Office Action Summary

10/797,441

- 1) ☒ Responsive to communication(s) filed on 21 September 2007.
- 2a) ☒ This action is **FINAL**. 2b) ☐ This action is non-final.
- 3) ☐ Since this application is in condition for allowance except for formal matters, prosecution as to the merits is closed in accordance with the practice under *Ex parte Quayle*, 1935 C.D. 11, 453 O.G. 213.

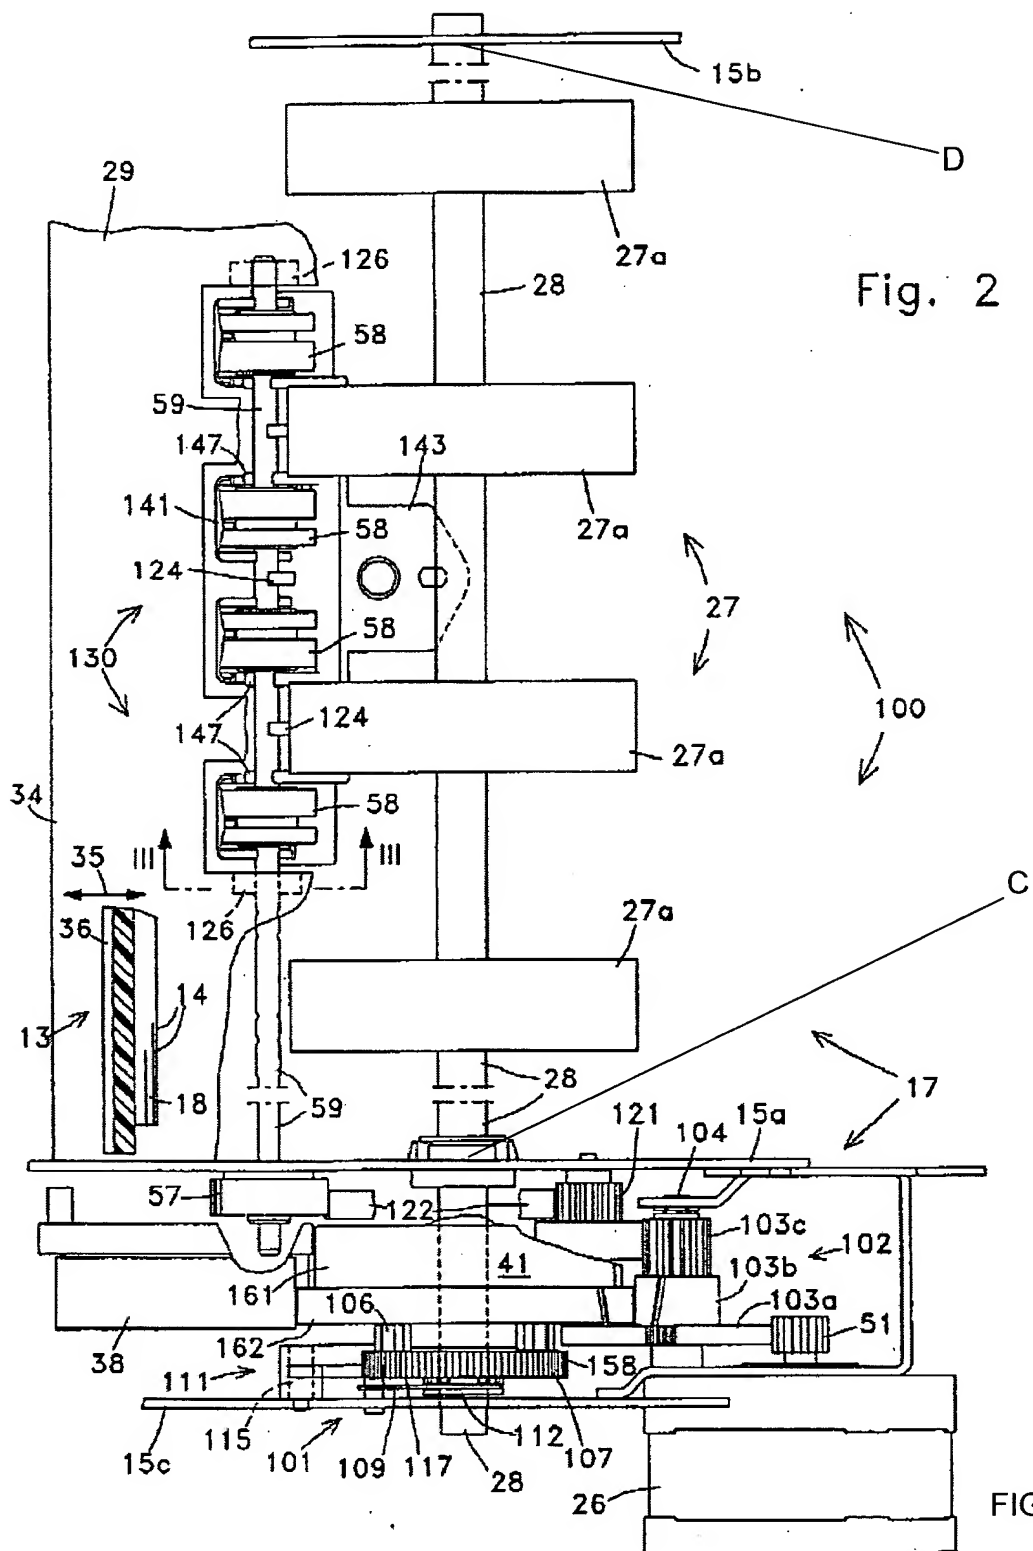
Claim 1: automated banking machine currency dispenser picker arrangement (100; column 1, lines 6-11); picker shaft (28); drive shaft (110); picker roller (27); currency cassette (13); drive end (See Fig. 2, bottom end of 28); drive mating portion (See FIG. G1 below, C); opposite end (See FIG. G1 below, D); resilient tab portion (15b; Note: portion of 15b connected to D supports D);

Claim 1: male mating portion; female mating portion; drive mating portion; other of the male mating portion; [other of the] female mating portion.

Claim 1 ("G2"): male mating portion (21); female mating portion (22); drive mating portion (drawing 1); other of the male mating portion (23); [other of the] female mating portion (25);

for the purpose of easily replacing a picker roller from the front side of the device (paragraph [0008]). Therefore, it would have been obvious to a person having ordinary skill in the art at the time the invention to modify Donnis as taught by Hiroshi and include Hiroshi's similar device having the structures of G2 for the purpose of easily replacing a picker roller from the front side of the device.
